**SEAS DEADLINE 6 RESPONSE to APPLICANTS's SUBMISSIONS**  
**SINCE DEADLINE 5, ISH3, Action Points and ExQ3**  
**LANDSCAPE & VISUAL and CULTURAL HERITAGE**

**PINS Ref:** EN020026  
**DEADLINE 6:** APRIL 13, 2026

# EN020026 SEA LINK DCO – DL6: RESPONSE BY NICHOLAS BRIDGES

## ZTV ANALYSIS – IP ref FA62B0DA

Figure 2. EN010078-001425-6.2.29.7 EA2 ES Figure 29.7 Onshore Substation ZTV (with landscape character)

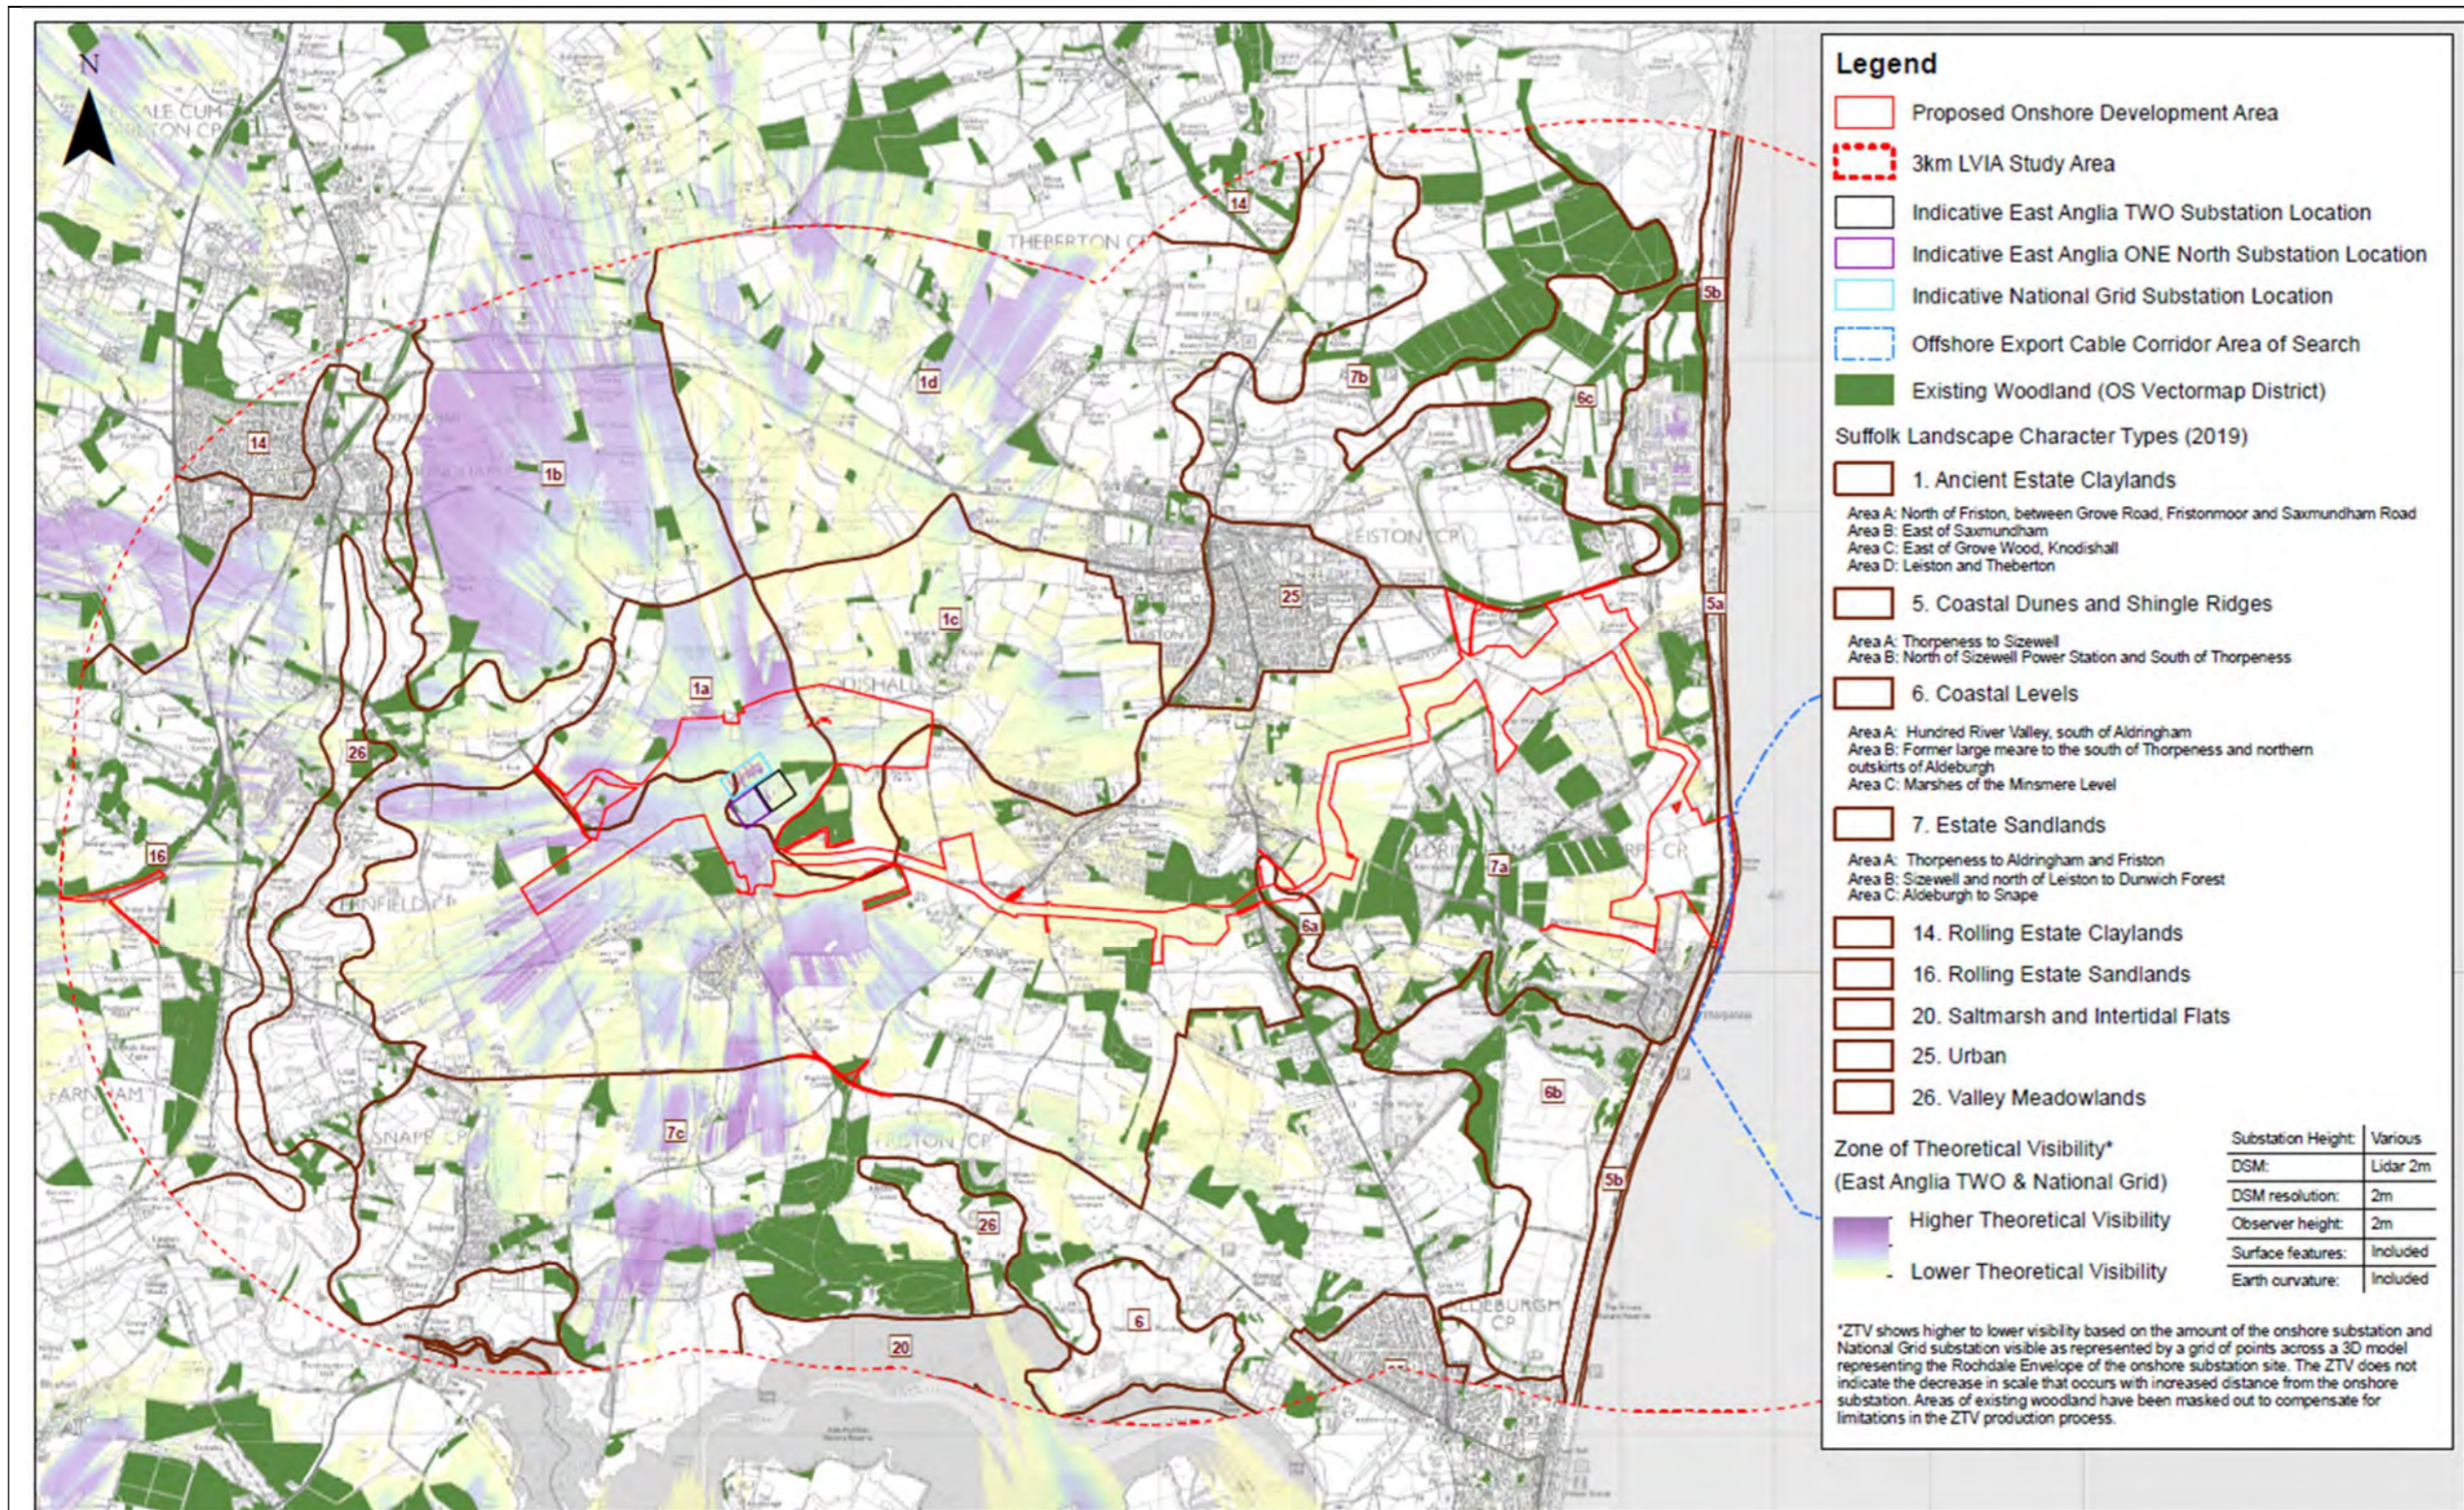
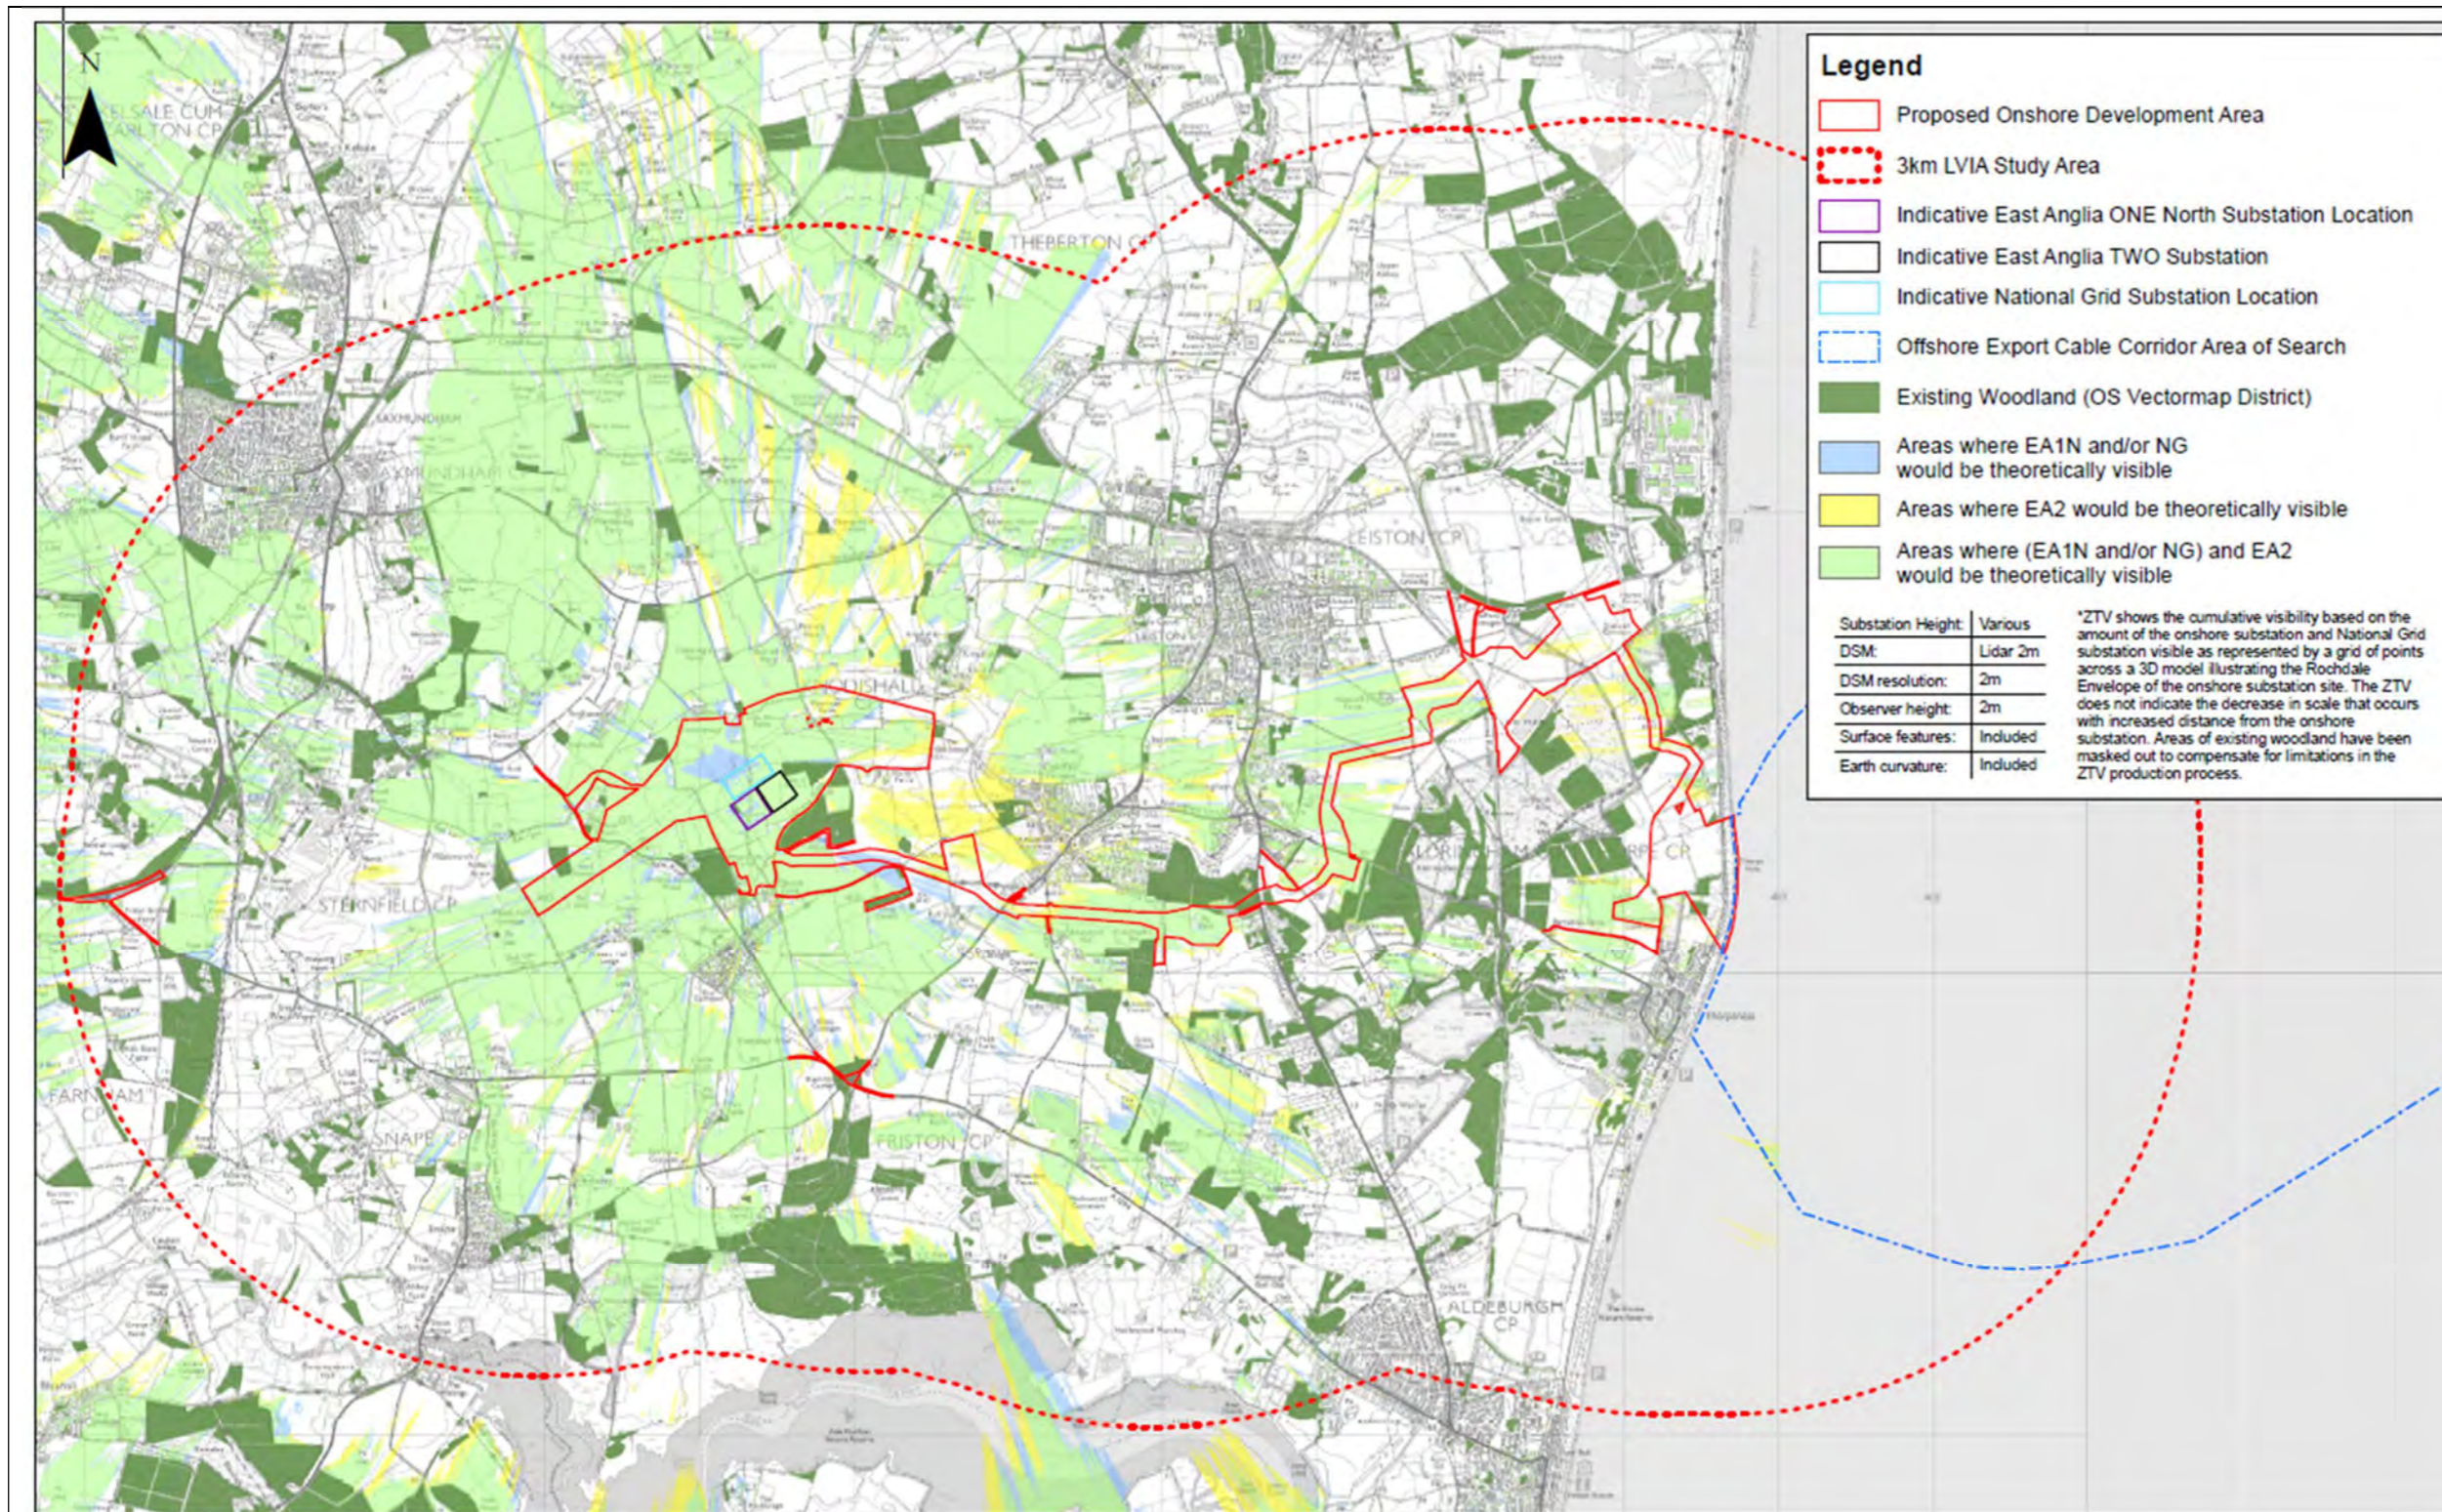
2.9. The ZTVs of the two Friston projects and Sea Link's PEIR have a similar pattern of visibility around their projects (see **Figures 1 to 11** below). Sea Link includes the National Grid substation at Friston which each of EA1N and EA2 also included. All Projects were modelled using OS contours, woodland and buildings at a generic height. Observer heights were a little higher for EA1N and EA2. The two Friston substations used the same parameter model as Sea Link.

2.17. The applicant does not seem aware of the EA1N and EA2 ZTV plans (**Figures 1, 2 and 3** below) which show that those developments would be visible. Nor the Sea Link PEIR likewise. Visibility from the top of the church tower is not relevant as the public have no access nor is it important as a private viewing point, unlike the Martello Tower for which this use was its primary function.
